SUBJECT: D/G03 series parts consolidation

In an effort to consolidate components for D/G03 and M03/G13 series pumps, beginning with serial number 407624, all S, B, and G cams will be supplied with K03 diaphragm plates, diaphragms, and valve plates.

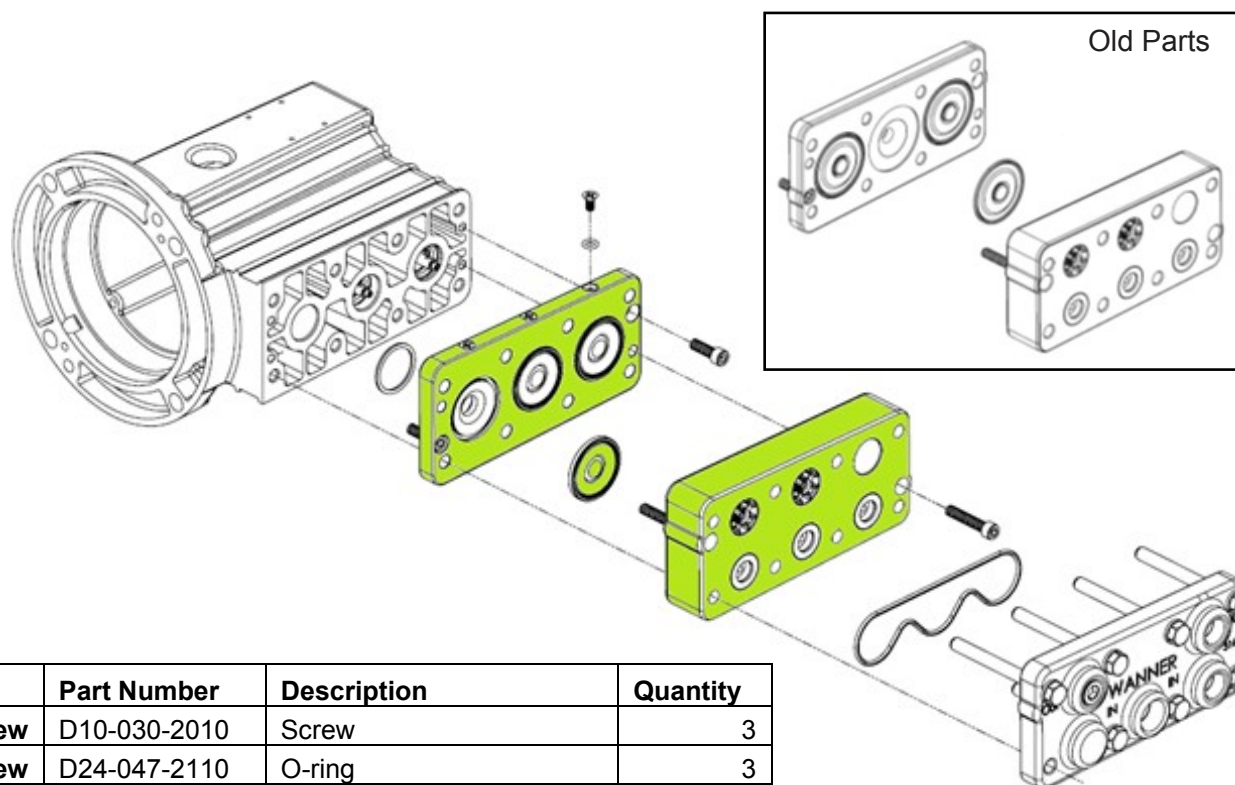
Part Number	Description	Quantity
New	D10-030-2010	Screw	3
New	D24-047-2110	O-ring	3
Old	D03-002-1000	Diaphragm Plate	1
New	K03-002-1022	Diaphragm Plate, Kel-Cell	1
Old	D03-018-12XX	Diaphragm	3
New	K03-018-12XX	Diaphragm, Kel-Cell	3
Old	D03-003-10XX	Valve Plate	1
New	K03-003-10XX	Valve Plate, Kel-Cell	1

- Changes are fluid end only, therefore pumps are not considered Kel-Cell.
- Pump performance (flow and pressure) are unchanged.
- Use the following Repair Kits: K03D51-XXXX, K03V51-XXXX, and K03K51-XXXX
